**Permit Application Review Report**  
**Date: 4/22/2026**

**Project Name:** SP 0217-36 TH610 and East River Road Interchange

**Project PAN:** P-25-033

**Recommendation:** Approve with 1 Condition and 4 Stipulations

PLOT NAME: d021736\_325enc  
 PLOT DATE: 3-MAR-2026  
 PLOT TIME: 2:14:00 PM  
 PROJECT: C:\Users\pjm\OneDrive\Projects\18221009-ORD\04\_Production\01\_CAD\Highway\Sheets\021736\_325enc.dgn

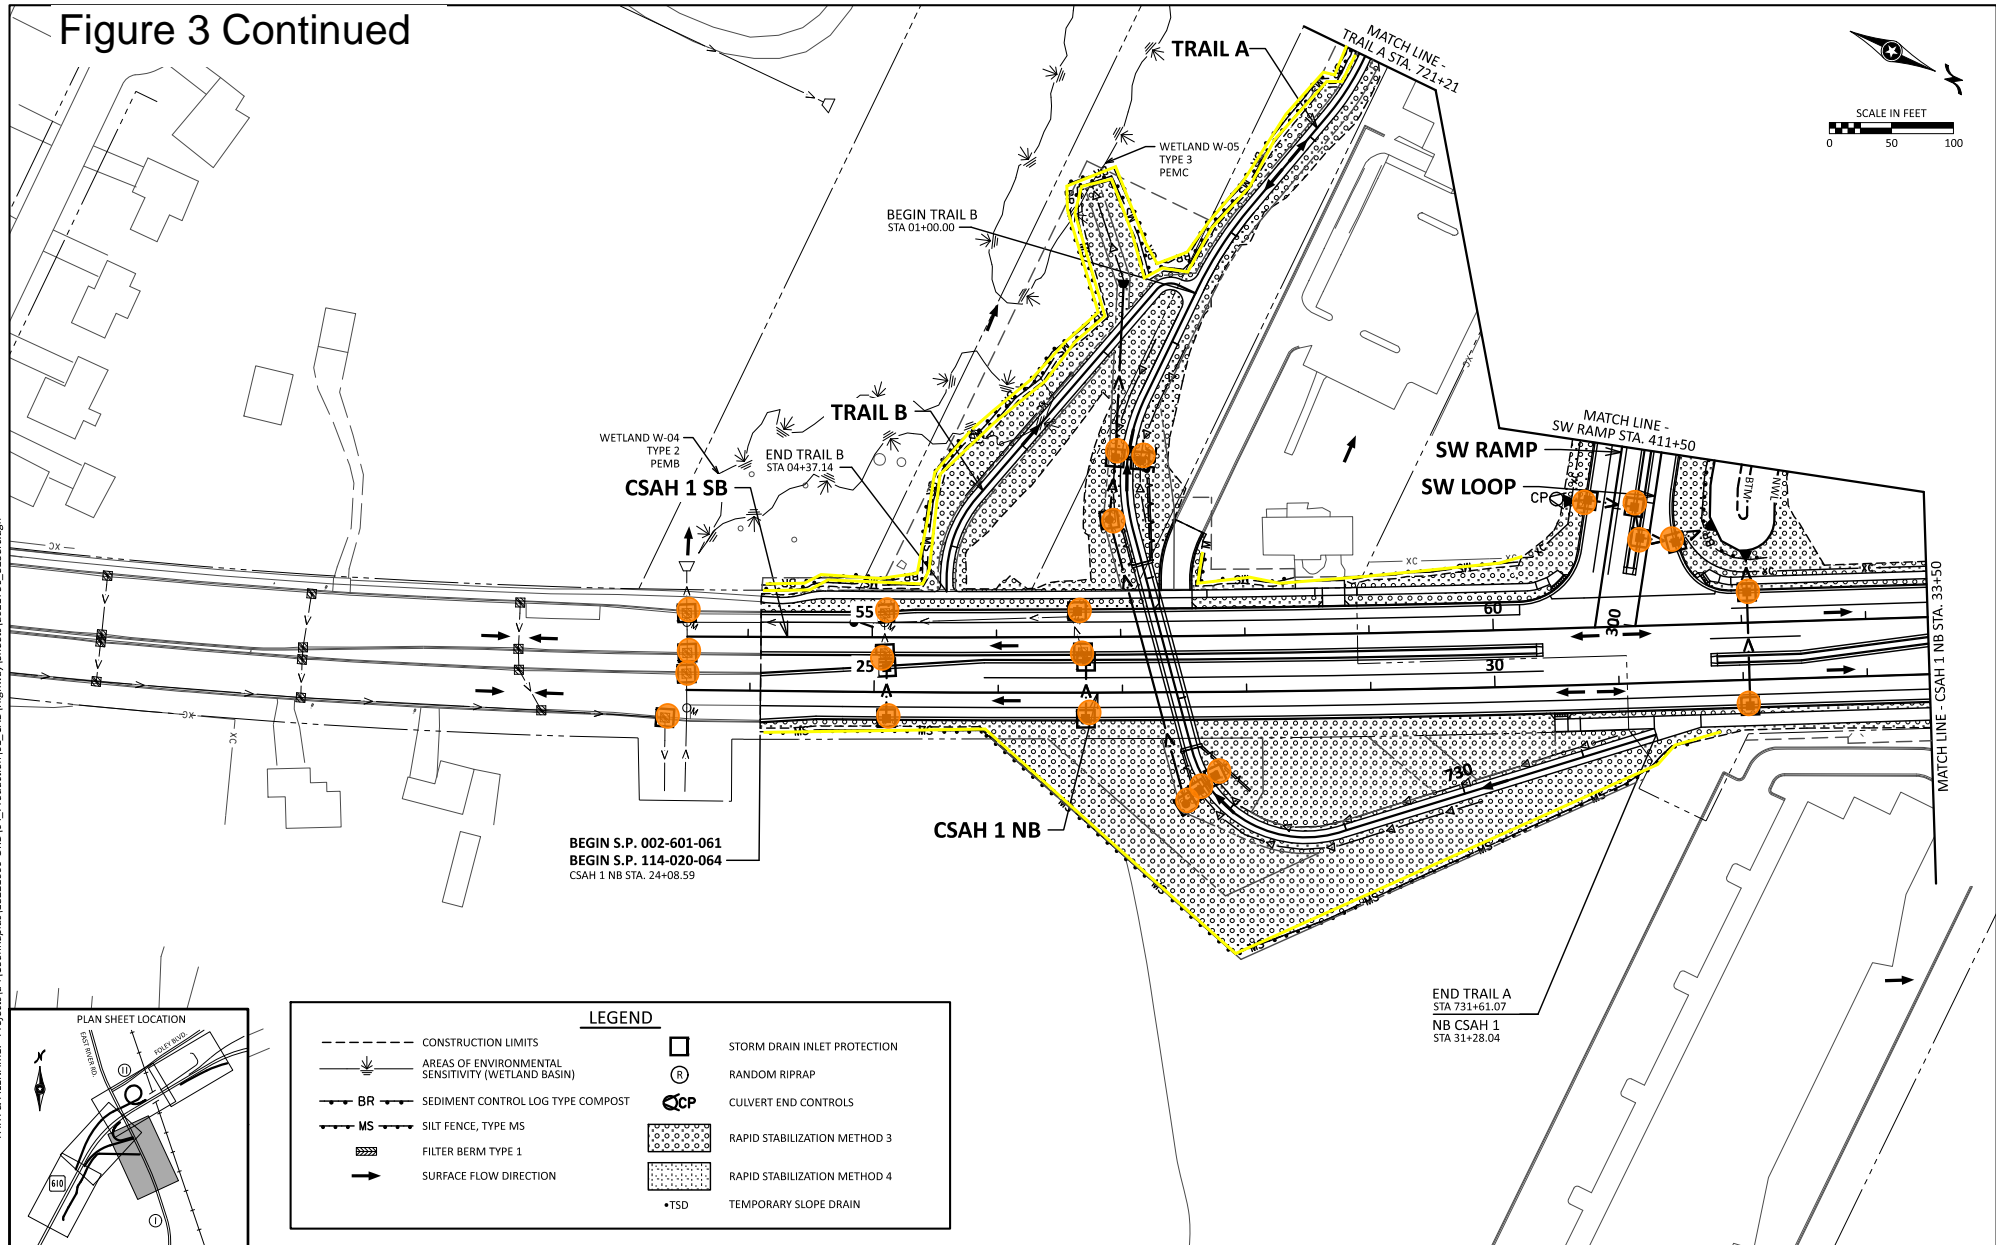
Portions of the proposed project drains to Lower Coon Creek and Pleasure Creek. The soils affected by the project includes Zimmerman and has a soil erodibility factor of 0.15 or greater. Disturbed areas are proposed to be stabilized within 7 days, as required. The proposed erosion and sediment control plan includes inlet protection, perimeter control, stabilized construction entrance, and street sweeping. The erosion control plan meets District requirements. The site does require an NPDES permit. See attached Figure 3: Erosion and Sediment Control Plan.

# Figure 4: Wetland Impacts

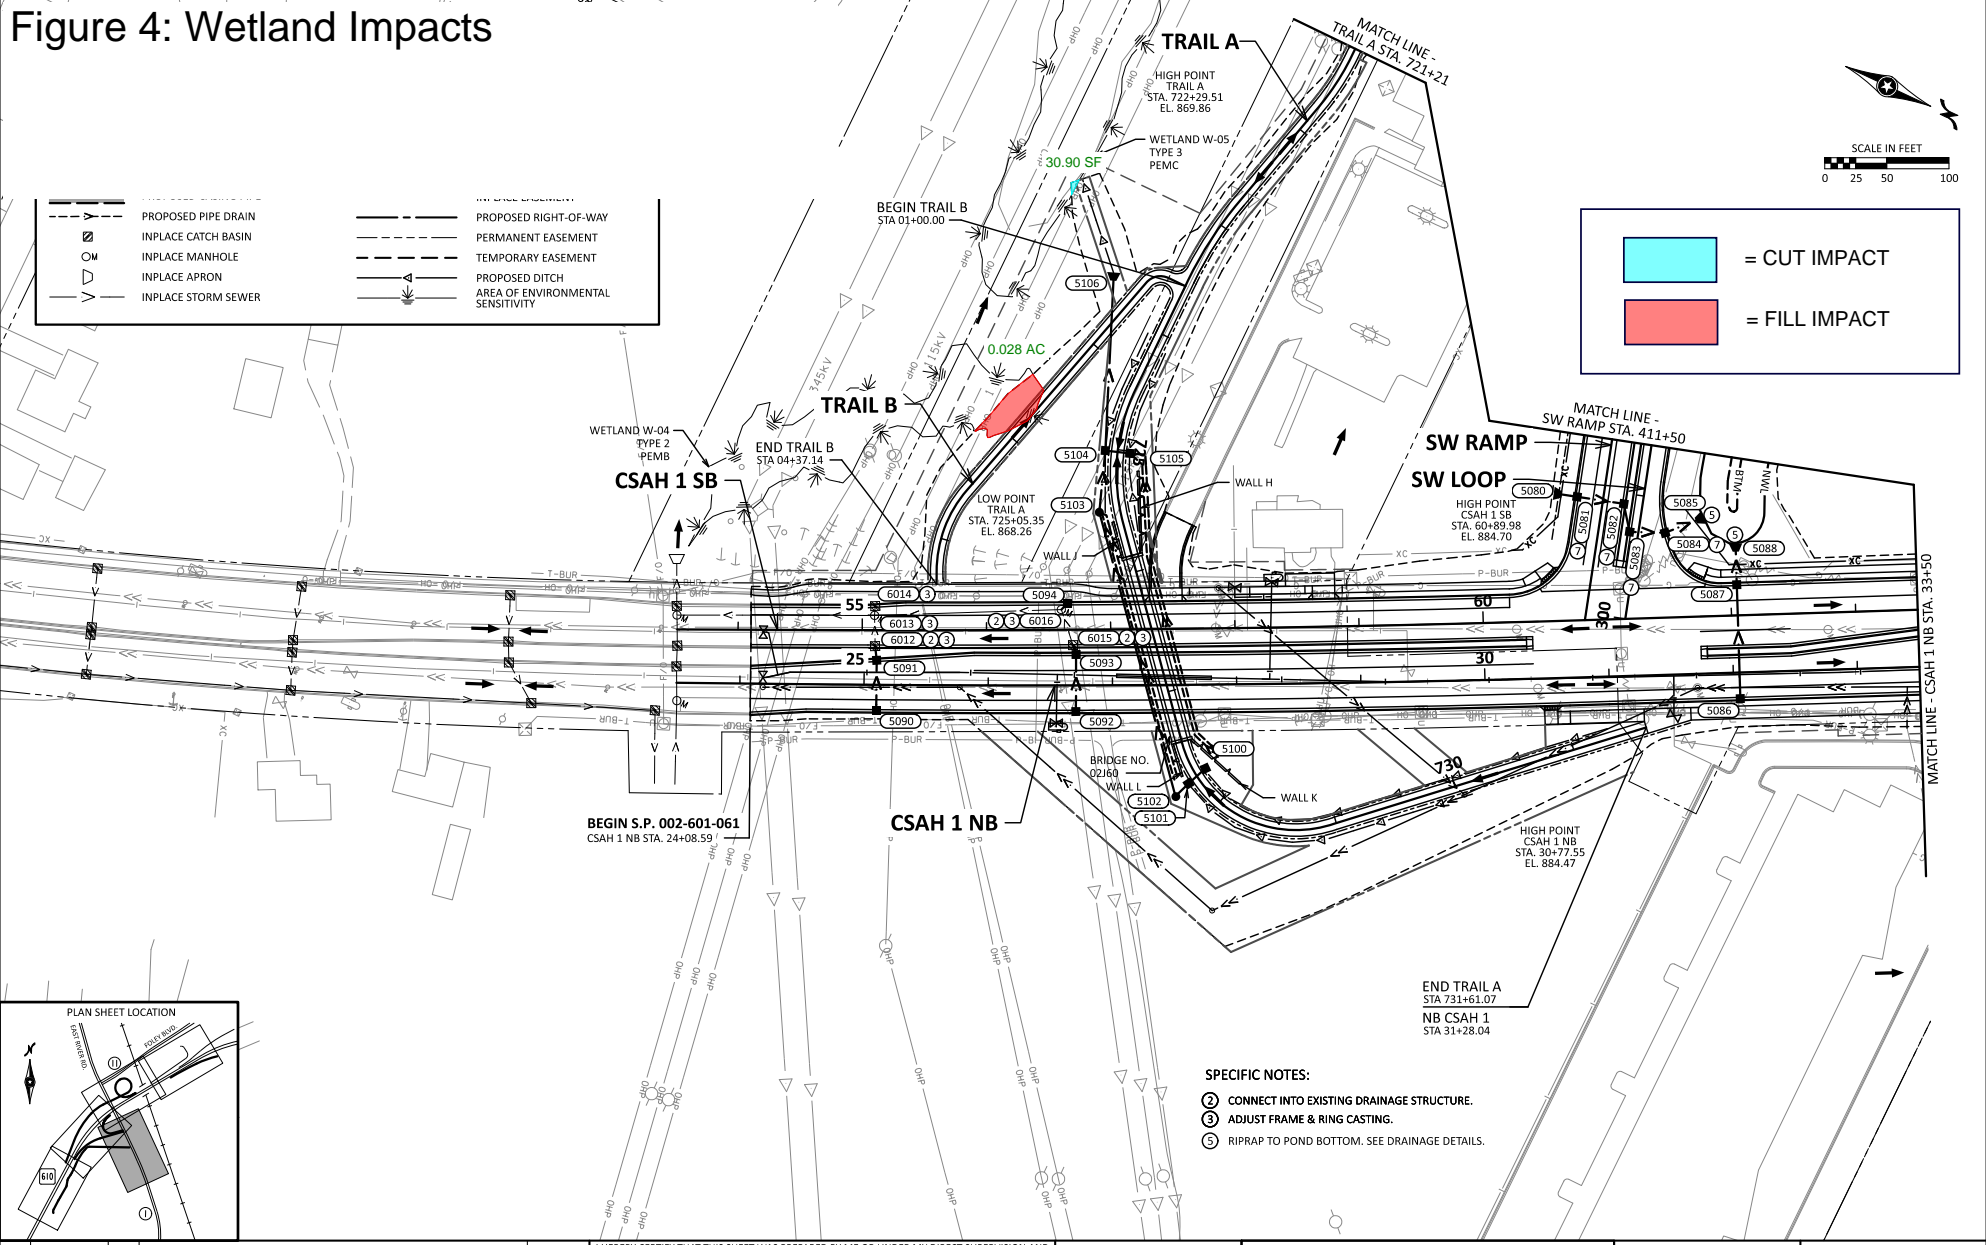
The applicant submitted a joint application form requesting an Exemption decision on 11/06/2025. The application was noticed to the TEP on 1/24/2025. Wetland impacts are proposed through cut and fill in 2 locations. The applicant has provided an alternatives analysis which discusses wetland impact avoidance, minimization, and mitigation. A wetland impact summary is outlined below.

The TEP agrees that the proposed project meets the requirements for an Exemption under MS 103G.2241 Subdivision 9. The Notice of Decision was issued on 12/18/2026. See attached Figure 4: Wetland Impacts.
